**GENERAL
CORRESPONDENCE**

Date: Tue, 20 Mar 2007 13:54:46 -0700 (PDT)
From: "L. Peter Galusky, Jr. P.E." <lpg@texerra.com>
Subject: Addenda for Vacuum N-6-1, K-35-1 and E-2
To: "Edward J. Hansen" <edwardj.hansen@state.nm.us>
CC: "Kristin Pope" <kpope@riceswd.com>

RE: Rice Operating Company
Vacuum K-35-1 Boot
UL K Sec 35 T17S R35E
OCD Case Number 1R0425-03
Corrective Action Plan

RE: REQUIREMENT TO SUBMIT ABATEMENT PLAN

Excavation Cross-Section

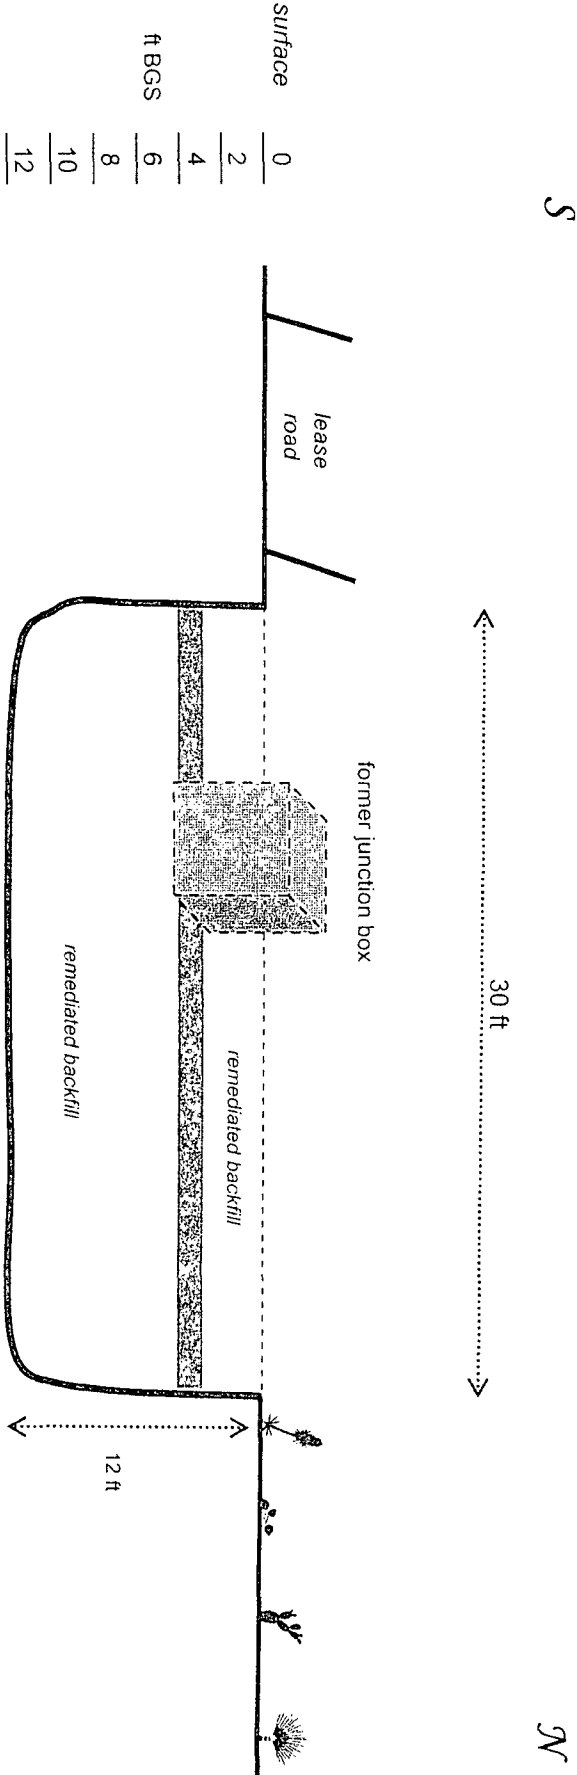
As constructed cross-sections of clay liners: Please find the attached images for each site, which were prepared b I have also included photographs to supplement the drawings.
